UNITED STATES PATENT AND TRADEMARK OFFICE

10/598,155

Office Action Summary	Application No. 10/598,155	Applicant(s) SORENSEN ET AL.	
	Examiner SEAN M. MICHALSKI	Art Unit 3724

DETAILED ACTION

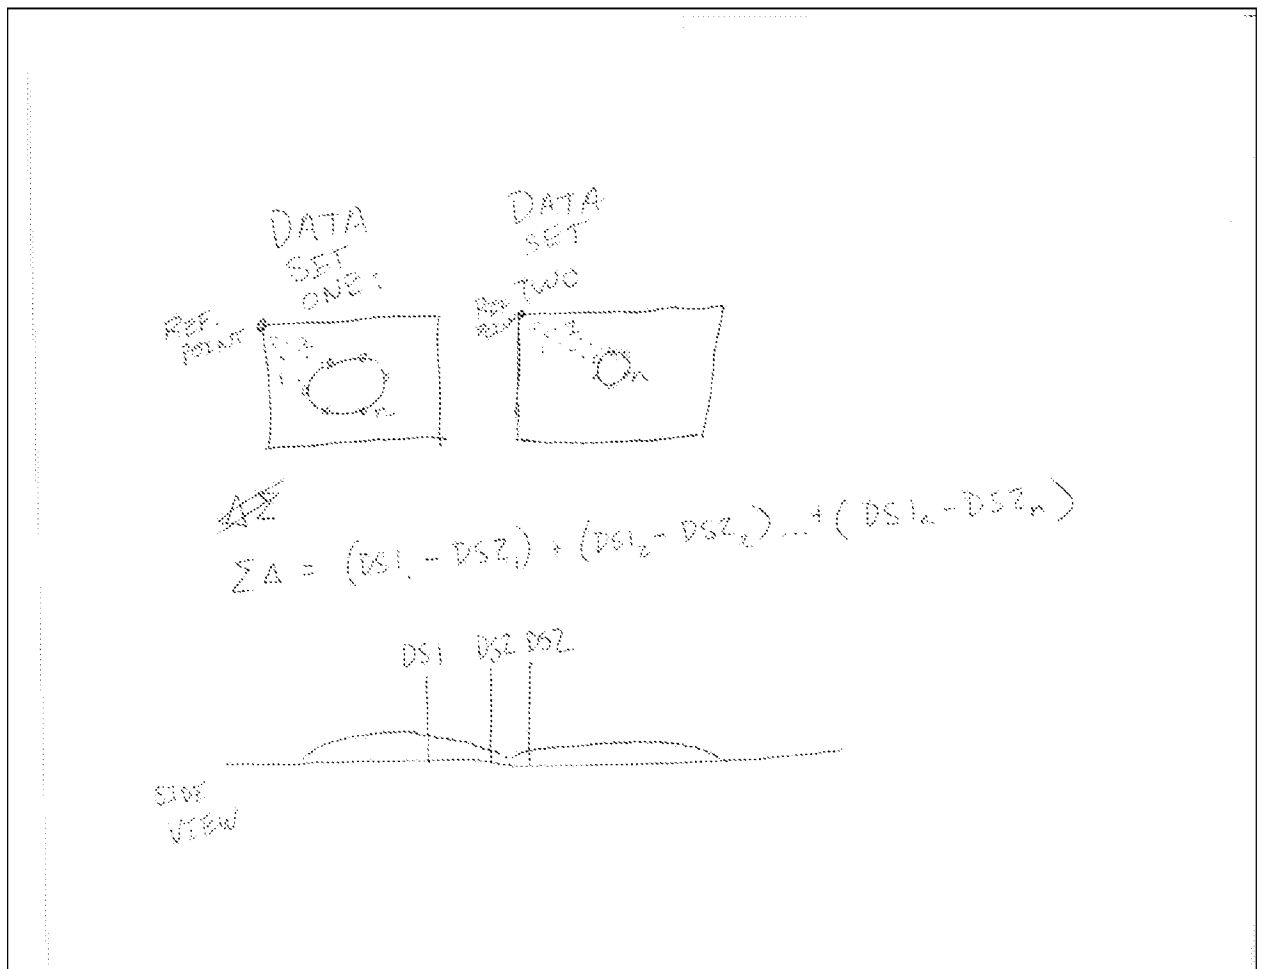
The specified "method" of "detecting a boundary" is to measure the size of the piece at a cross section (at radial points 1, 2, 3, 4, n... exactly as in Whitehouse) and then to compare those positions/ distances to adjacent distances (1', 2', 3' 4', n') and then measure the difference and sum the total. This way when the piece decreases in cross sectional area *all the points of measurement* decrease and the summation of the differences spikes up (since the differences are larger).

This is flawed, since any cross sectional change can trigger the same spike as it is alleged a boundary will do, and yet the application provides no way of being able to determine what are true boundaries and what are false positives. there is no way the direction of comparing the sum of the differences can lead to actual repeatable boundary detection without undue experimentation.

Claim 35 sets forth that the boundary detection step involves comparison of "two successive data sets" without saying they are from item one and item two respectively, however the method does not include enough information to "analyze ...for identifying the boundary..." the sets of data (each "point" on the conveyor) would have to be arbitrary, since you don't know ahead of time whether the set represents item one or item 2. If there are two arbitrary sets of data as claimed, they would "look" like this:

From two “sets” of data, applicant claims that “Analysis” is possible to determine the “boundary” of the items- this is not true, since as seen in the above, having two sets of data will not give any information about the boundary, since the two marked “DS2” will be the same from an analysis viewpoint.
